IEEE P802.3at Task Force Power Via MDI Enhancements

Midspan/Channel Requirements below 1MHz – with 120uH
Addressing Draft D3.2 comment #78

Yair Darshan / Microsemi Corporation,
November, 2008

System Channel Model with 120uH vs 350uH (without Midspan)

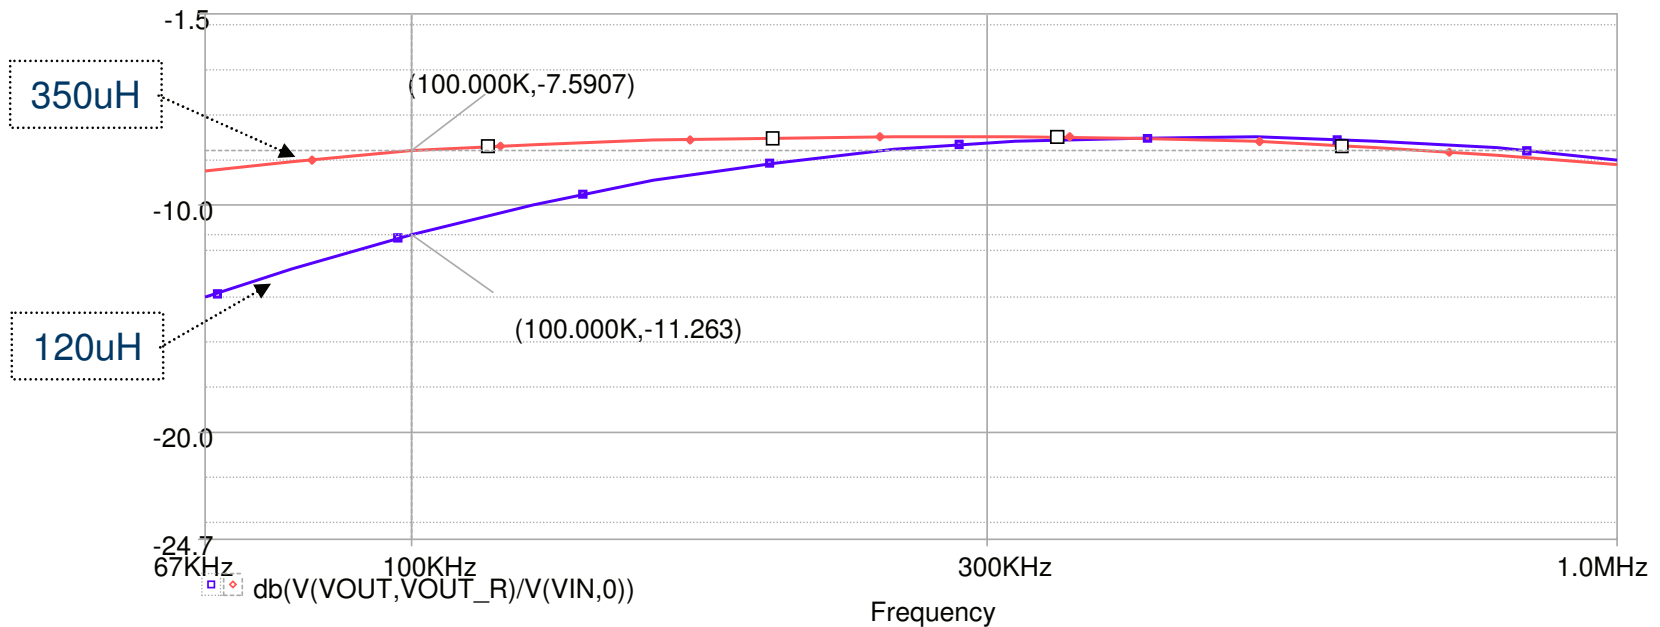
1. Now, the 120uH curve represent the System Channel Model TF that Type 2 system need to meet. The 350uH curve represent the previous System TF with 350uH.

Midspan TF comparison: Simulation Verification

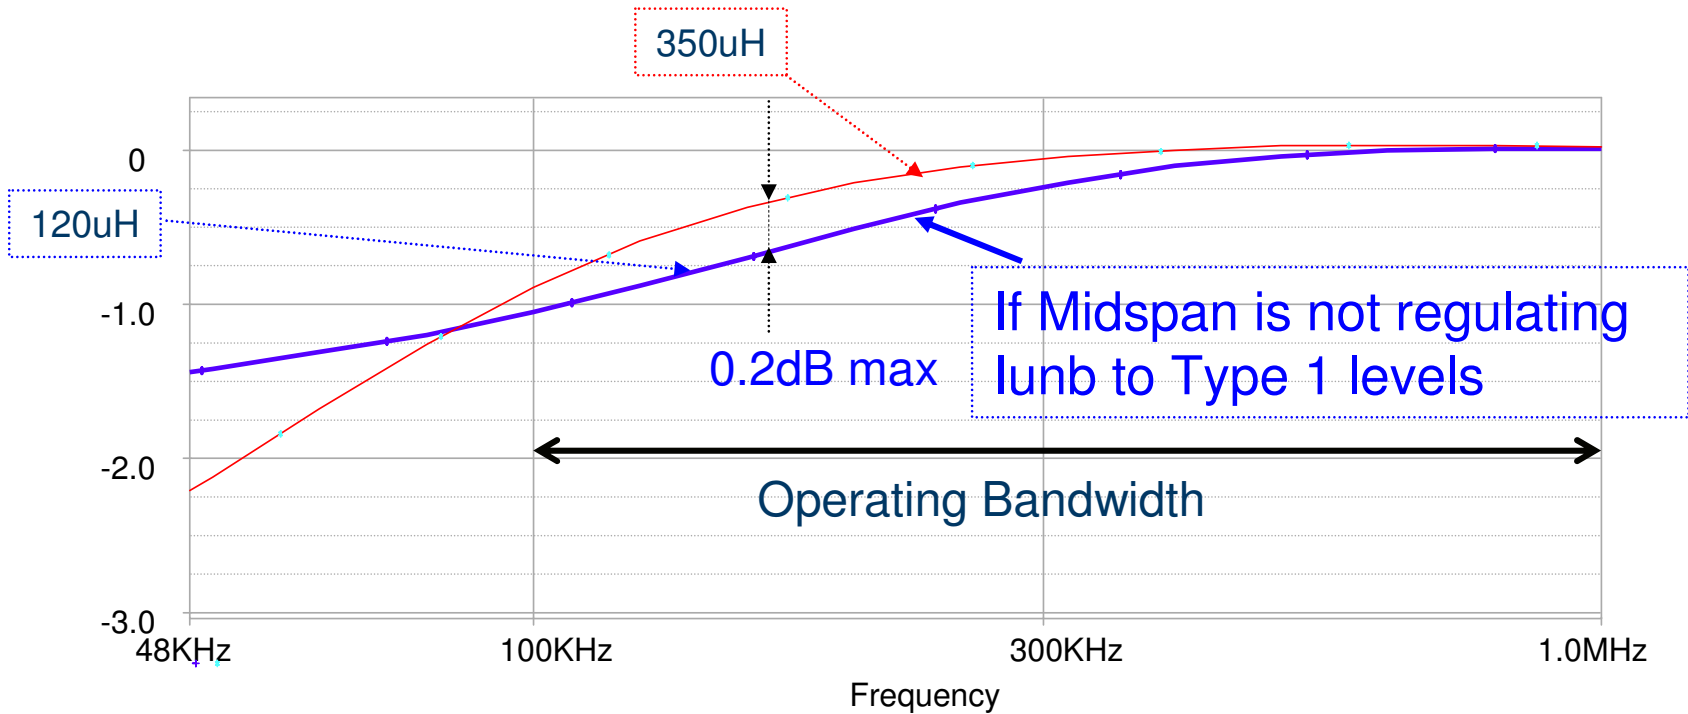
The worst case difference is 0.2dB and varies with frequency

- Eq 33-18 is not affected due to the requirement that Midspan need to regulate L_{nb} to Type 1 levels hence OCL in PD and Switch stays as in Type 1 systems i.e. 350uH minimum.
- At the worst case that Midspan is not regulating L_{nb} , it will change Eq 33-18 by 0.2dB max due to the 120uH minimum at the PD as function frequency over the operating frequency range.
- Recommendations for Draft D3.2 comment #78
 - When ALT A Type 2 Midspan is regulating L_{nb} to Type 1 levels, Eq 33-18 is not changed
